APPLICATION NO.	FILING DATE	FIRST NAMED INVENTOR	ATTORNEY DOCKET NO.	CONFIRMATION NO.
09/437,296	11/09/1999	MICHIO YAMAJI	991283	7789

Office Action Summary

DETAILED ACTION

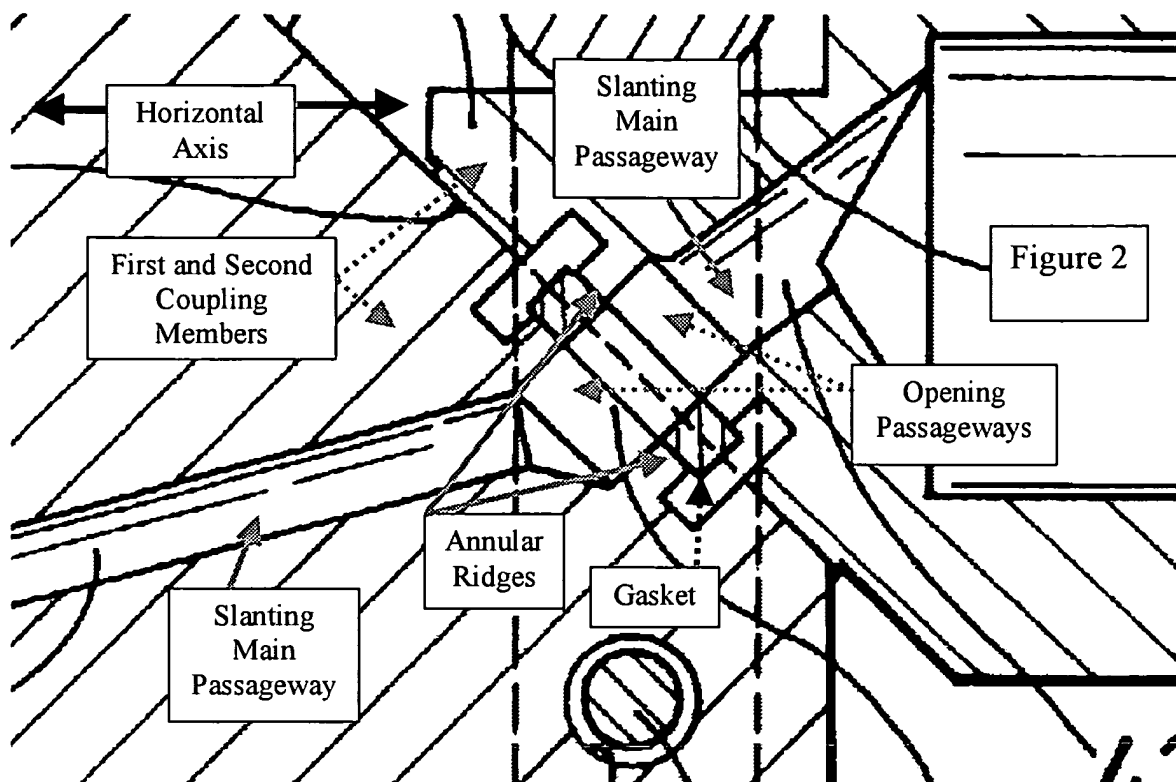
In regards to claim 1, in figure 2 below, Nakazawa et al discloses a fluid coupling comprising first and second coupling members having respective gasket holding annular ridges on butting end faces thereof; and

an annular gasket interposed between the first and second coupling members, wherein each coupling member has a fluid channel comprising an opening passageway orthogonal to the butting end face thereof, and a slanting main passageway communicating therewith, the opening passageway having a diameter equal to the inside diameter of the gasket holding annular ridge, and

the gasket holding annular ridges are in contact with the gasket at its radial midportion so as (capable) to relieve the inner peripheral portion of the gasket from stress concentration and wrinkles.

Nakazawa et al does not disclose the gasket holding annular ridges being rounded as to be in contact with the gasket only at its radial midpoint. In Figure 4, McGarvey teaches gasket holding annular ridges (36, 38) being rounded as to be in contact with the gasket (12) only at its radial midpoint to produce a minimum dead zone volume condition (col. 1, lines 45-64). As McGarvey relates to face-seal fitting employing a metal gasket, it would have been obvious to one having ordinary skill in the art the time the invention was made to fabricate rounded gasket holding annular ridges as to be in contact with the gasket only at its radial midpoint to produce a minimum dead zone volume condition, as taught by McGarvey.
